Access Compliance Report Public Rights-of-Way (RR Crossings)

Intersection ID: 10025402	Main Street: E_BLAND_ST	Location: N/A
ADA ID: 1D3B4089D3F1	Overall Compliance: No	Severity Score: 0.0
Codes/Mitigation Info/Possible Solution		Field Measurements/Component Compliance

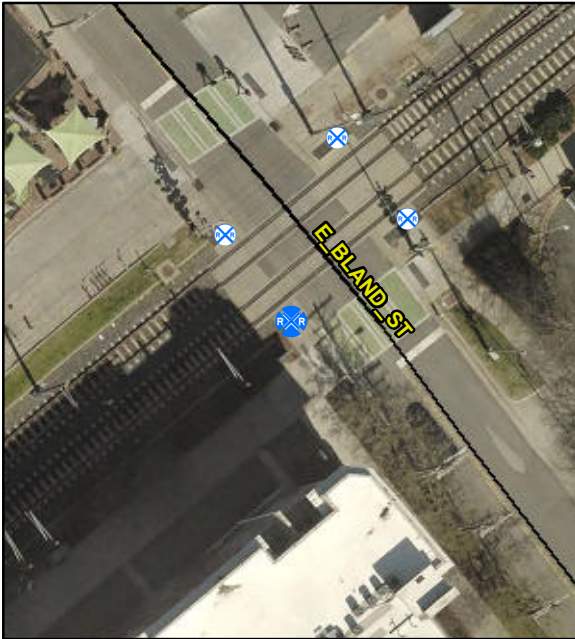
**Remove & Replace Detectable
Warning System. Provide Pedestrian
Gate. Remove & Replace Walking
Surface Adjacent to Rail.**

R302.7.4, R305.2.5

Compliance	Description	Data
Yes	DWS Provided?	Yes
Yes	DWS Contrast?	Yes
Yes	DWS Width (in)	Yes
Yes	DWS Length (in)	36.0
No	DWS Offset (in)	29.0
No	Pedestrian Gate?	No
N/A	DWS Outside Gate?	No
N/A	Rail Type?	LightRail
No	Flangeway Gap (in)	3.0
Yes	Sidewalk Width (in)	69.0
